Access Compliance Report

Public Rights-of-Way

(Curb Ramps)

| Intersection ID: 42643 | Main Street: E_3RD_ST | Cross Street: E_JOHN_BELK_RA | Location: E |

| ADA ID: AA475E52DBF7 | Ramp Type: Directional2 | Initial Pass/Fail: Fail | Overall Compliance: No |

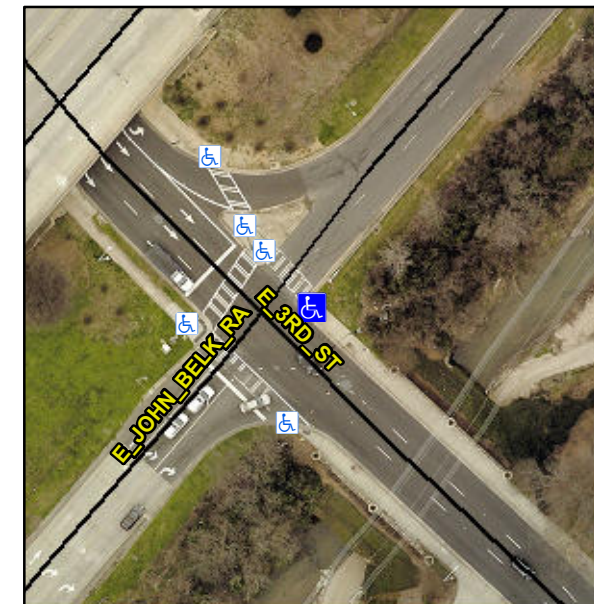
R304.2.2, R304.5.3

| Compliance | Description | Data | Compliance | Description | Data |
|------------|-----------------------|-------|------------|-----------------------------|------|
| No | Ramp Slope (%) | 16.4 | N/A | Grade Break XSlope (%) | 0.0 |
| No | Ramp XSlope (%) | 4.3 | | | |

Remove & Replace Entire Ramp.
